Docket Item #3 & 4
BAR #2018-00432 & 2018-00433

BAR Meeting
November 14, 2018

ISSUE: Partial Demolition and Addition

LOCATION: 439 North Peyton Street

PLAT
SHOWING DISTURBED AREA
LOT 542, BLOCK 1
WHEAT AND SUTER'S ADDITION TO
ALEXANDRIA, VIRGINIA
(INSTR. #180003988)
CITY OF ALEXANDRIA, VIRGINIA

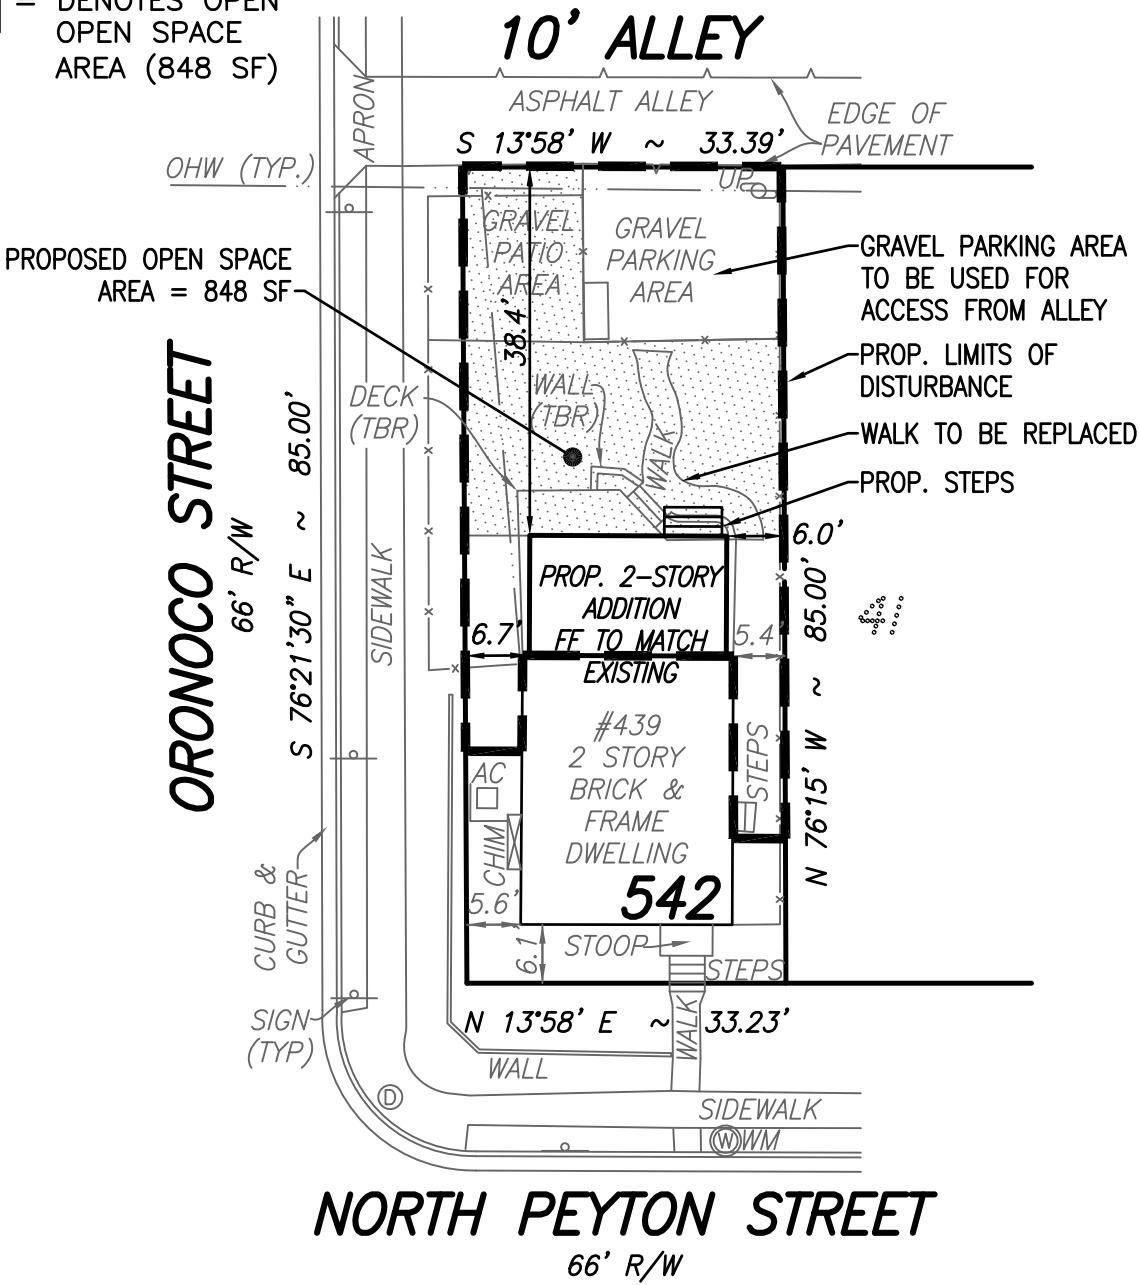
F-1 According to the submitted plat, the fence is located in the public right of way along Oronoco Street and likely exceeds the height of the previously existing fences.

2
A4
EXISTING REAR ELEVATION
SCALE: 1/4" = 1'-0"

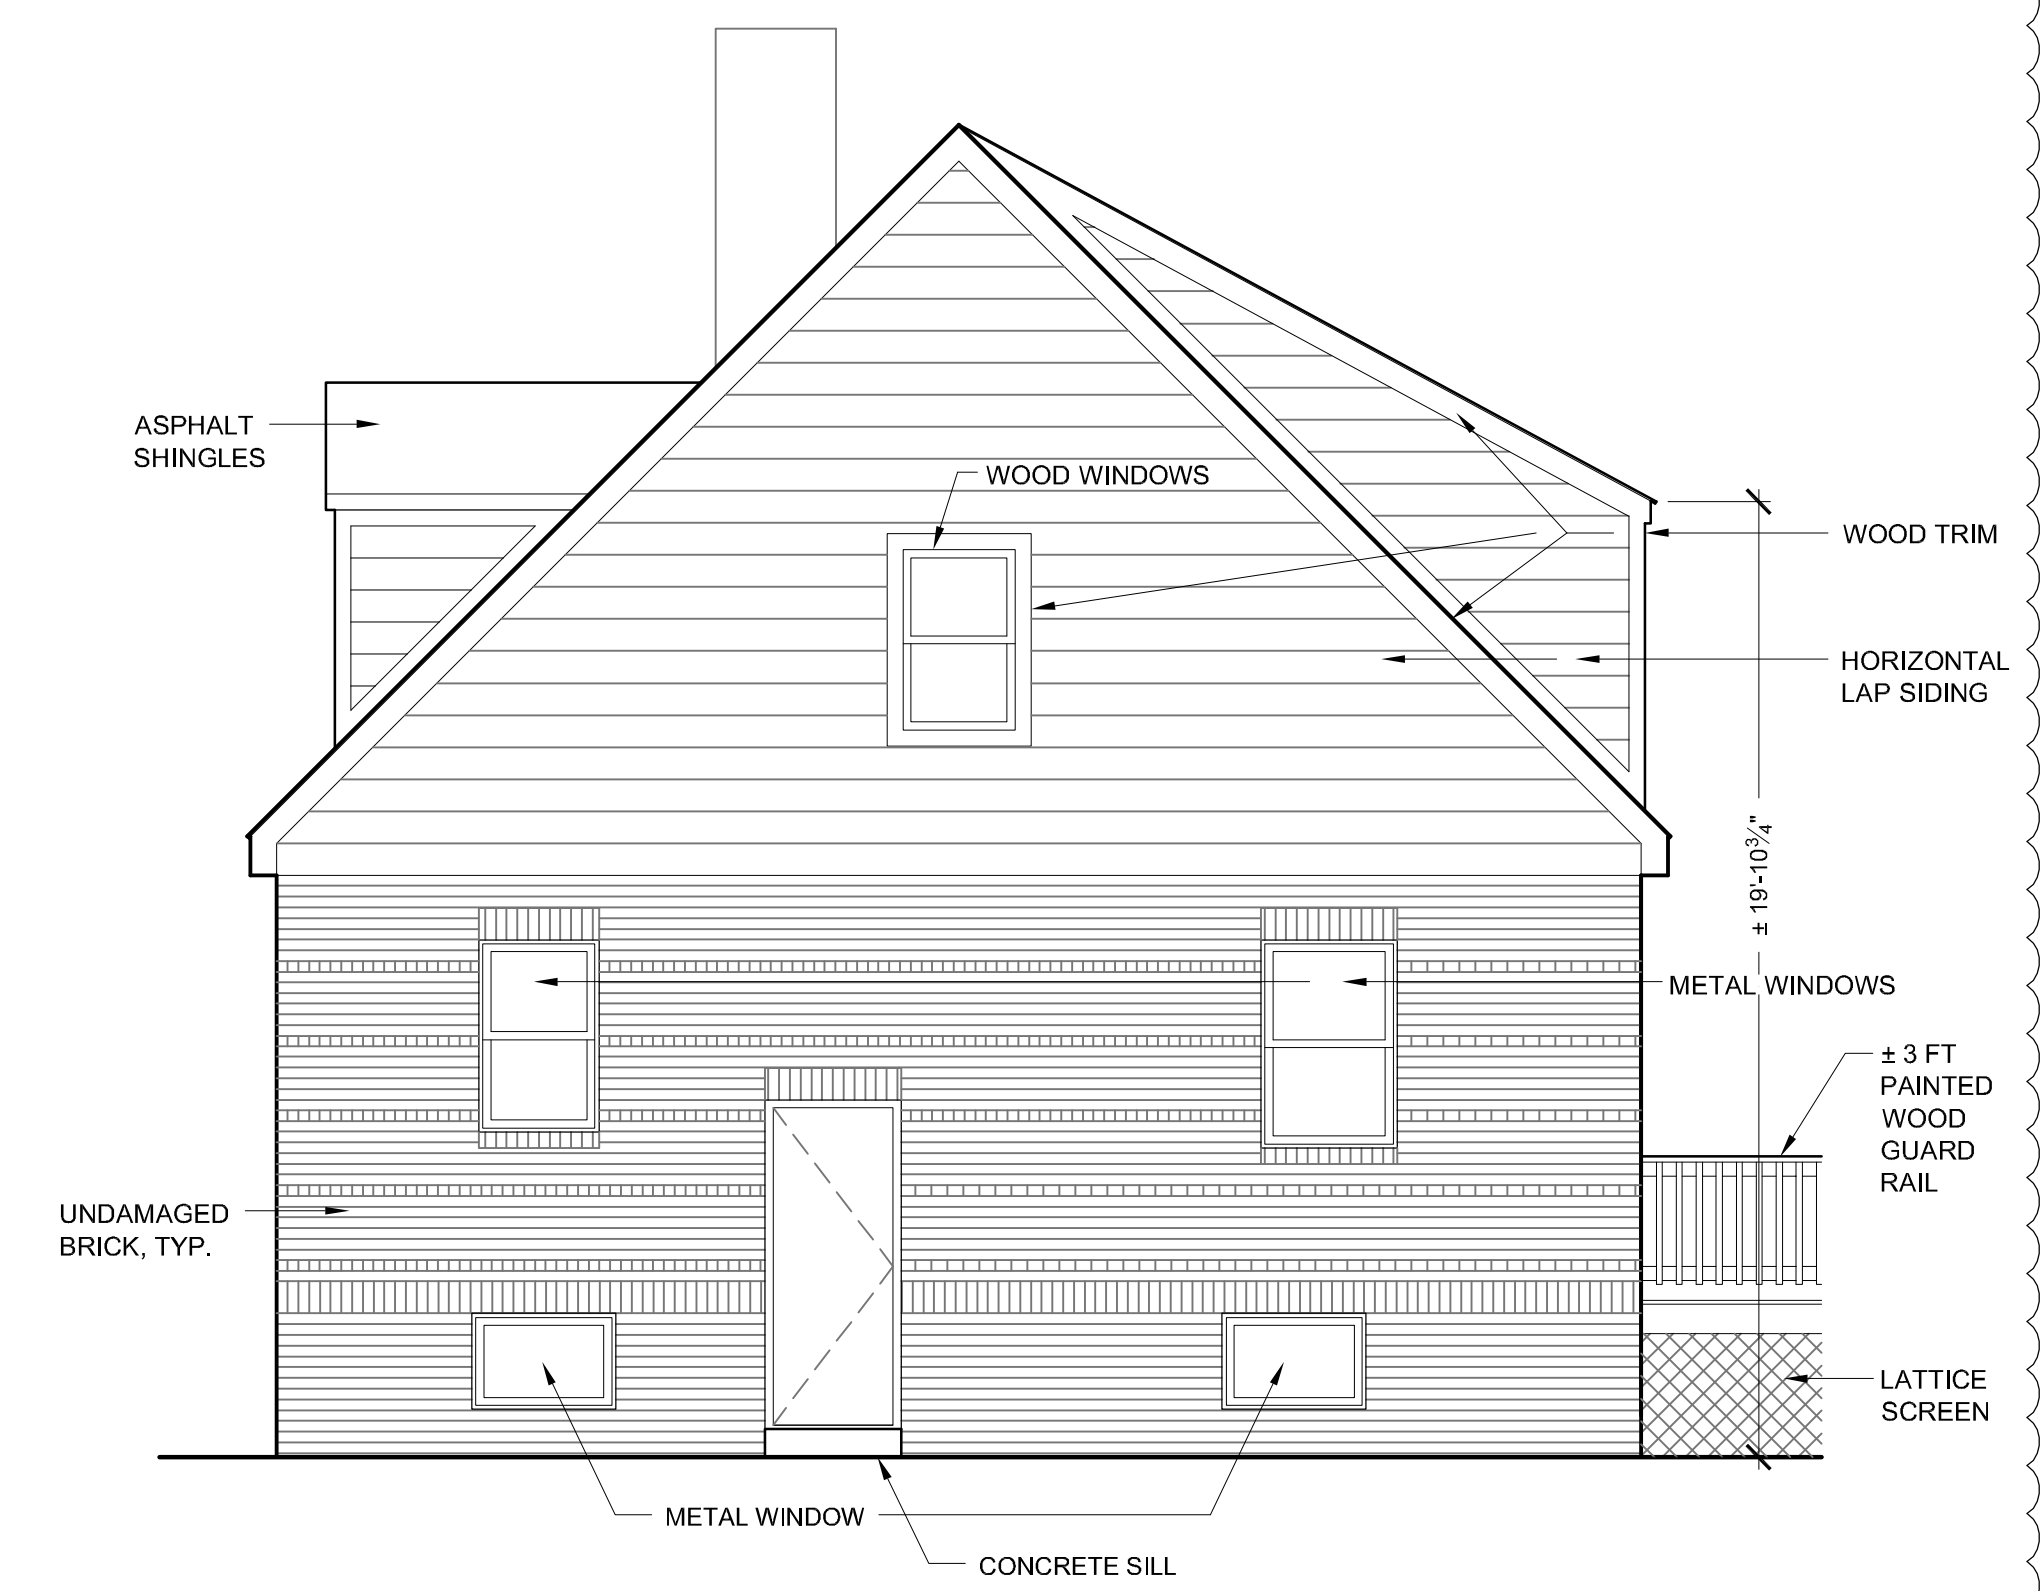
The applicant requests a Permit to Demolish to capsule/demolish the rear (east) wall of the existing house and the majority of the rear roof. The applicant also requests a Certificate of Appropriateness to construct a two-story rear addition. The proposed addition will be frame construction with fiber cement siding and will feature an intersecting gable roof with two shed dormers. The addition includes aluminum-clad multilight windows and doors, smooth fiber cement siding and architectural grade composition shingles.
